FARHANG AND MEDCOFF | 100 S CHURCH AVE, TUCSON, AZ, 85701 | 07.26.2021

## DESIGN PROFESSIONAL COMMENT RESPONSE

Project:	Farhang and Medcoff	Activity Number:	T20CM02335
Subject:	Design Professional Comment Response	Issued by:	Grace Schau
Date:	July 26, 2021

A5.0

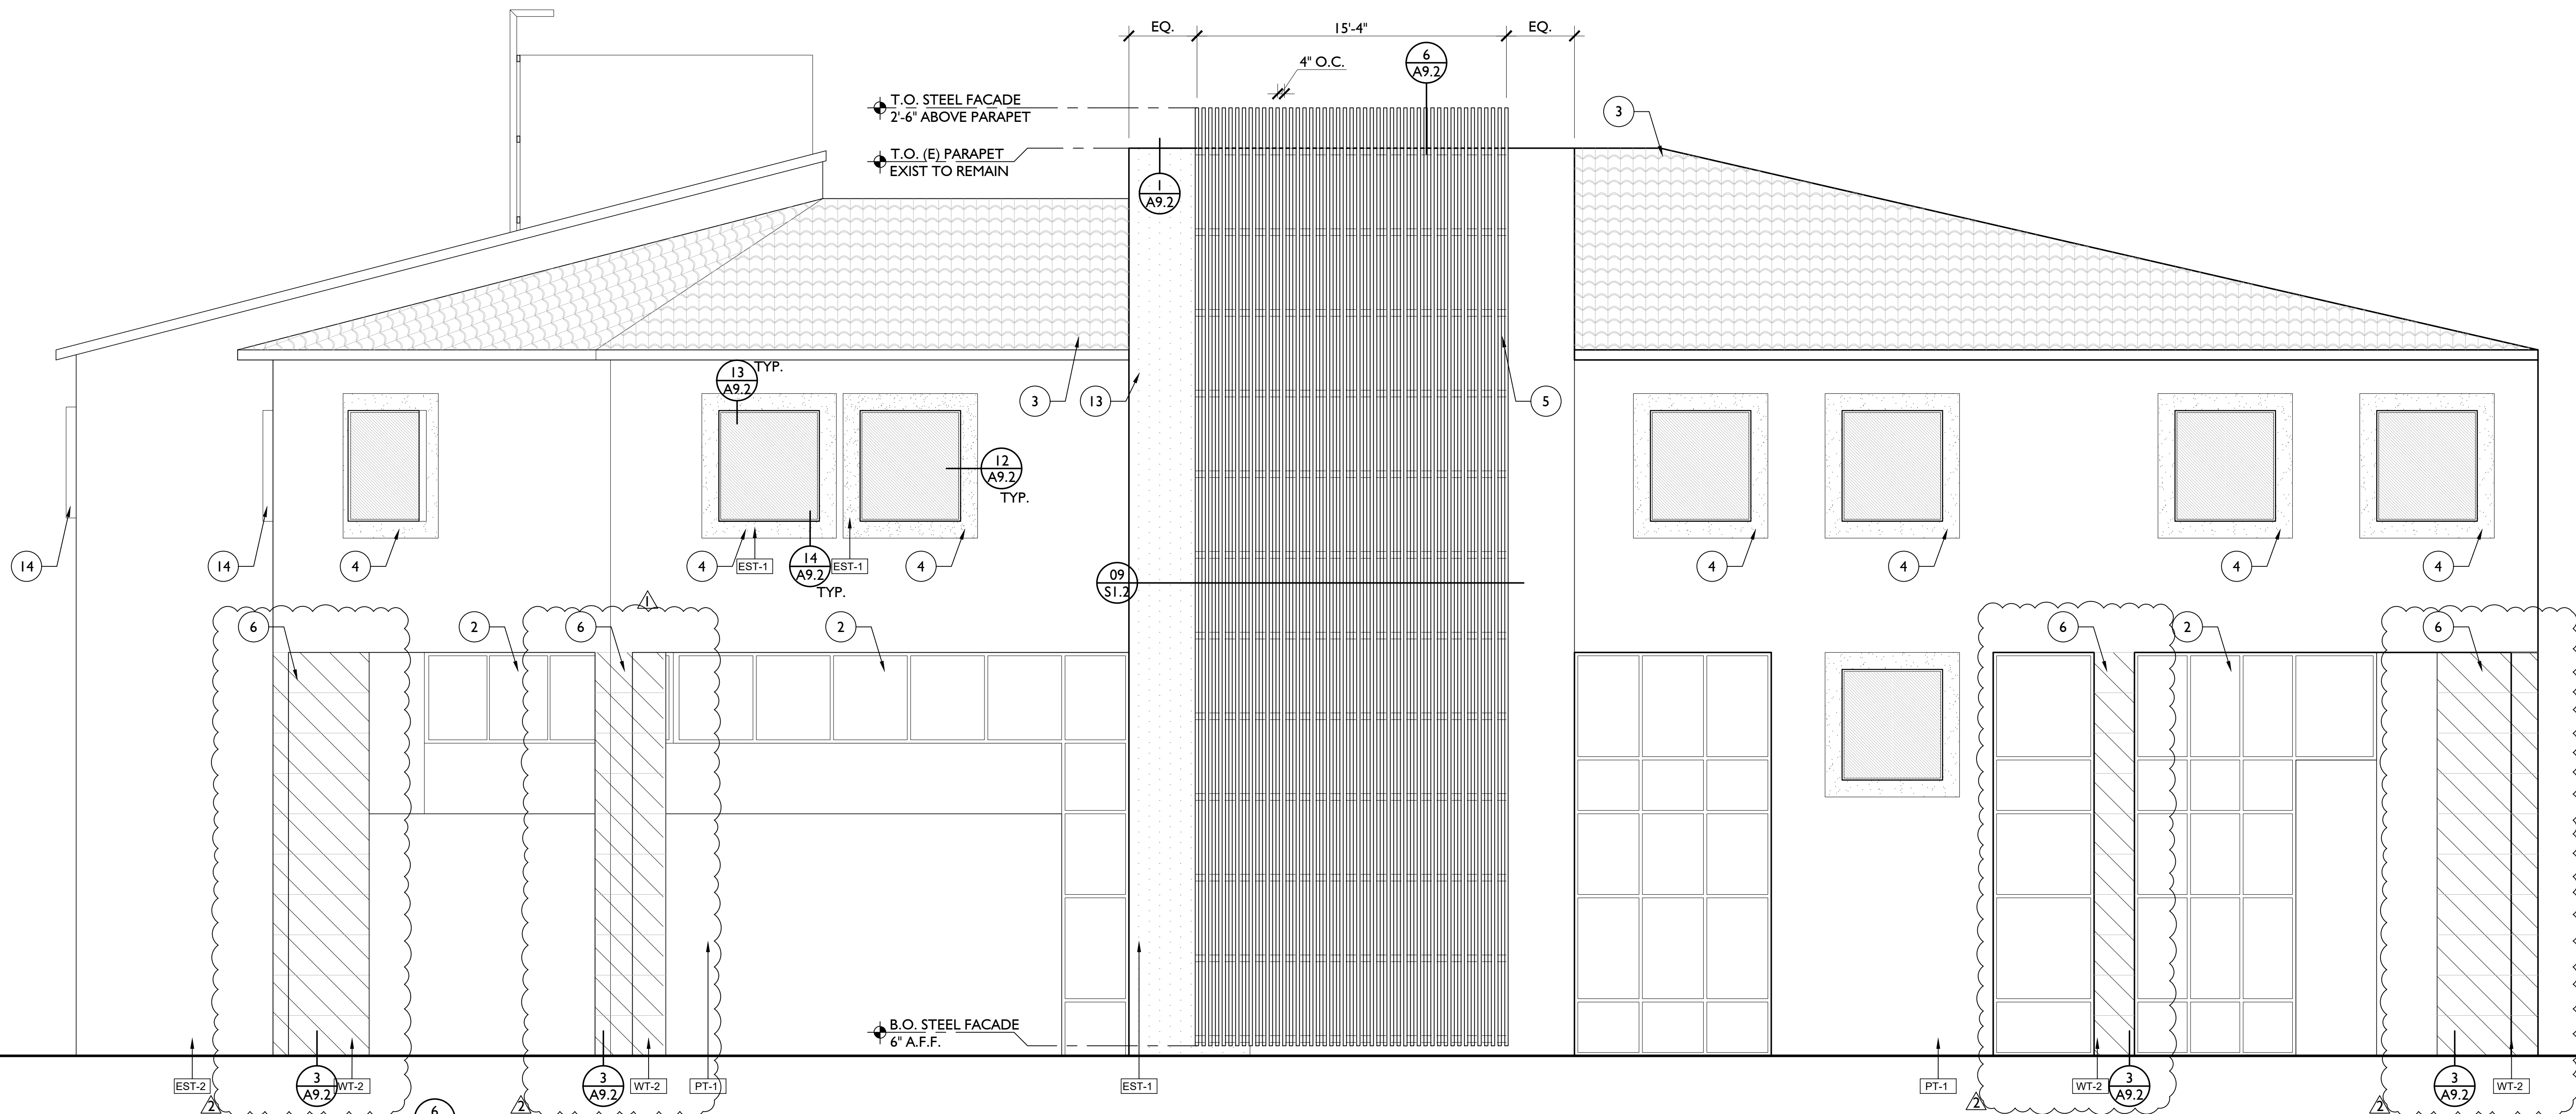
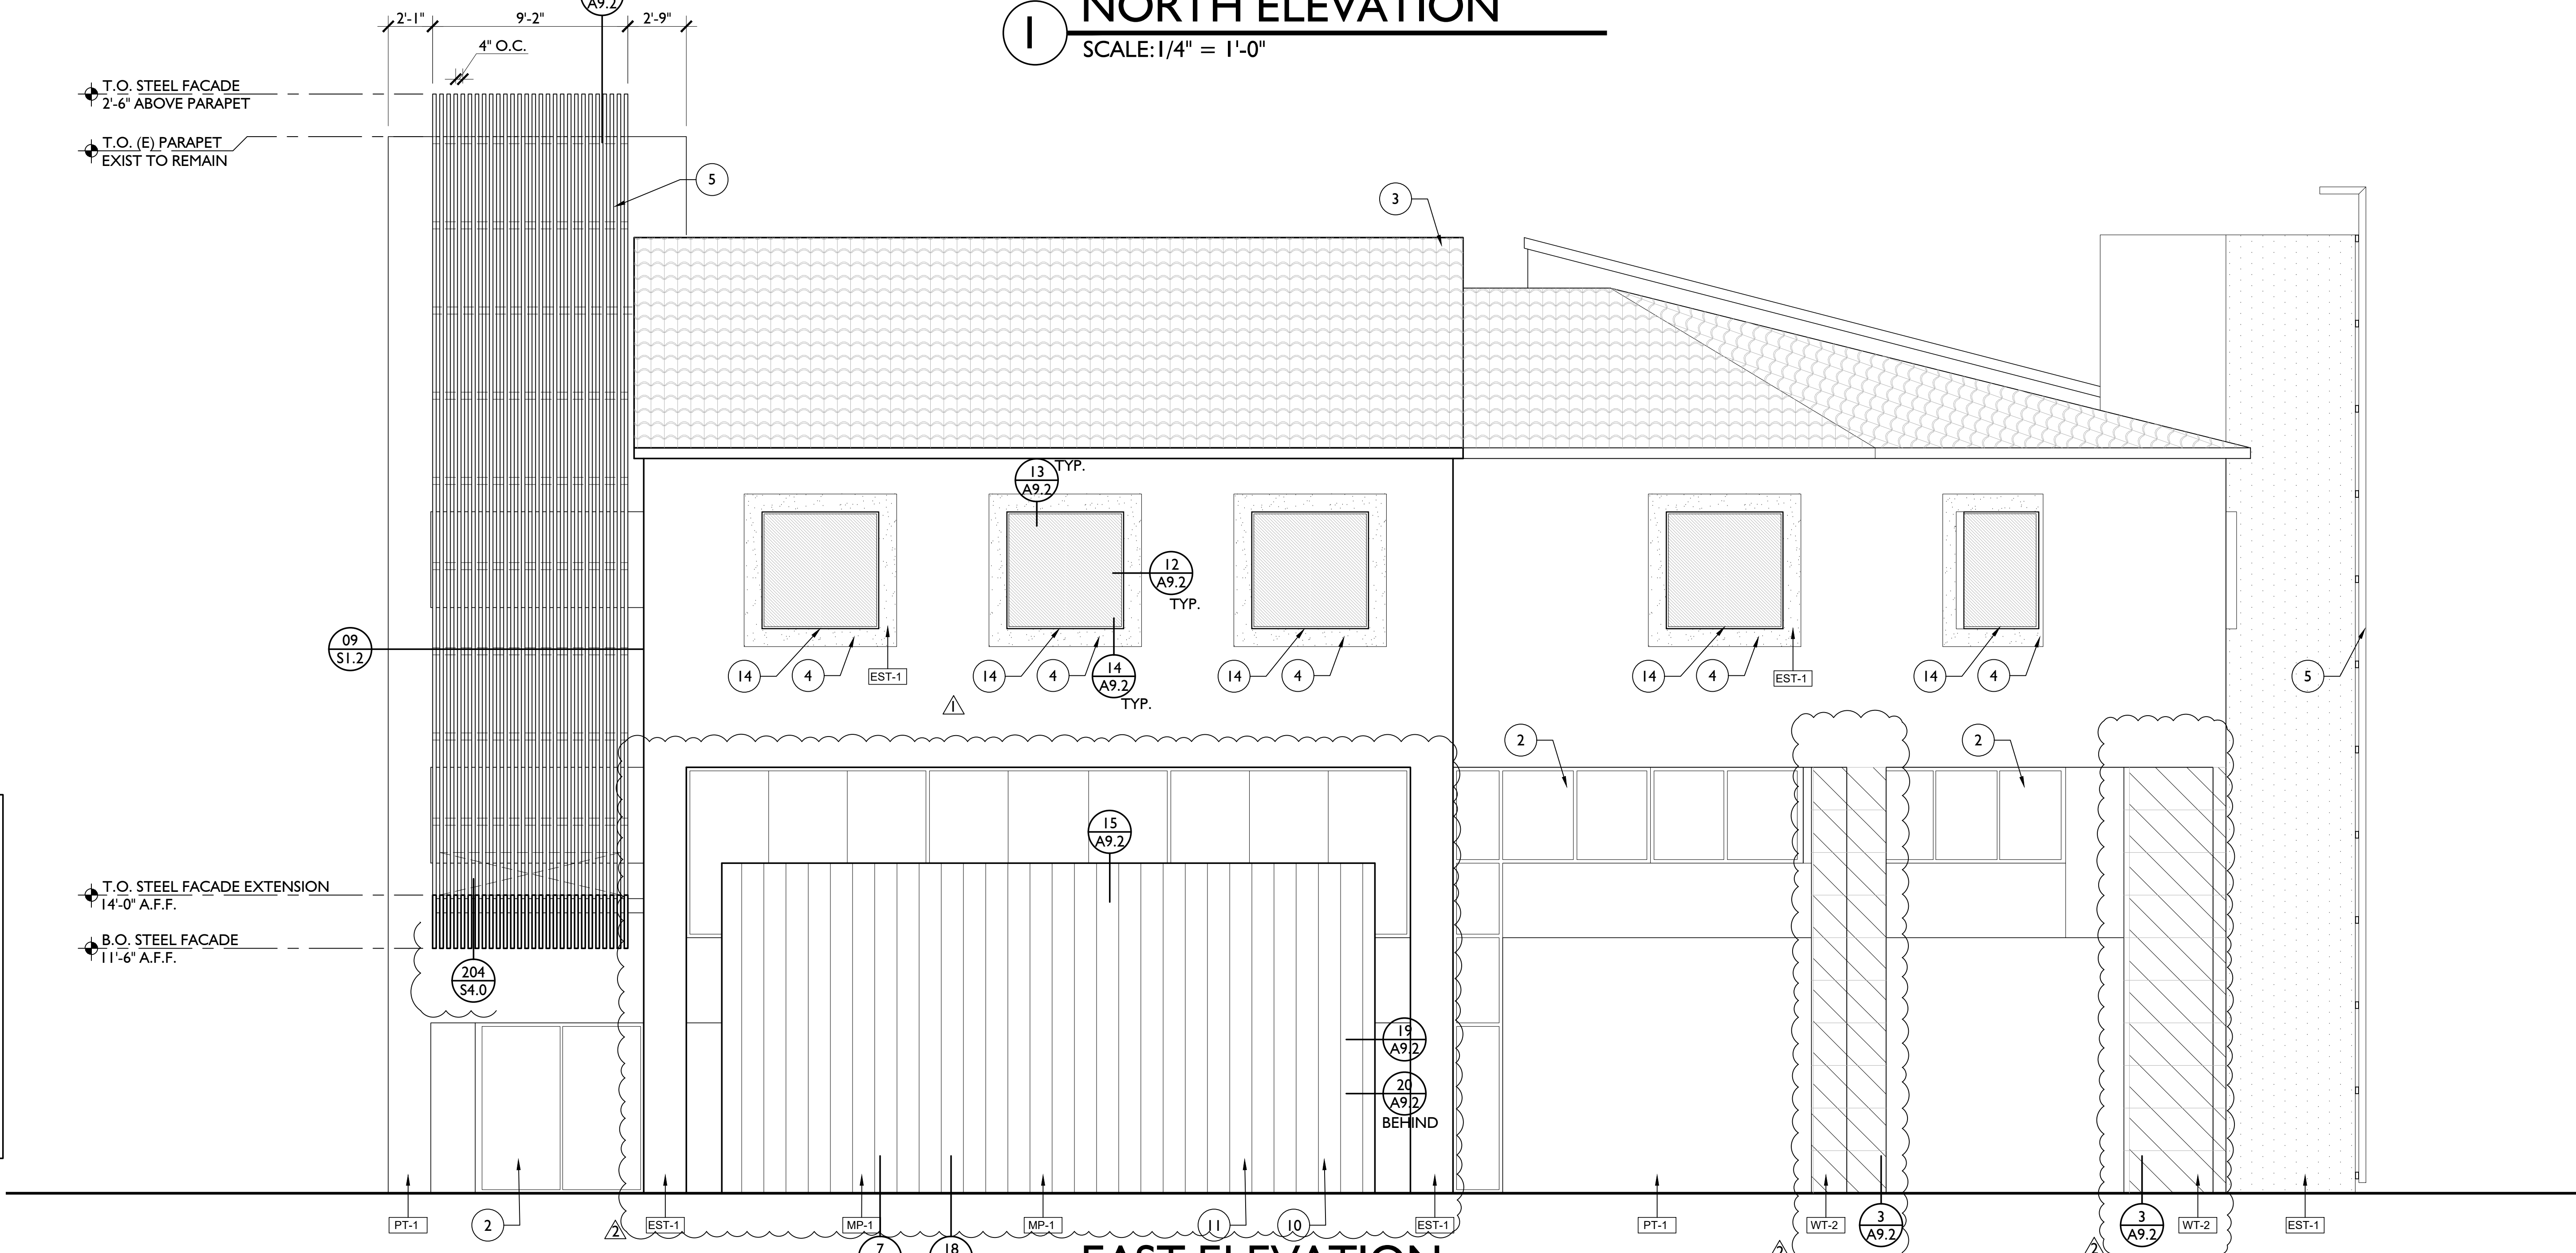
4. On Sheet A5.0, please revise the elevations so they match the elevations approved in the Design Package. Make sure to label all materials and colors as approved in the Design Package.

- o Please see the revised design package and elevations indicating the installed materials and colors for approval.
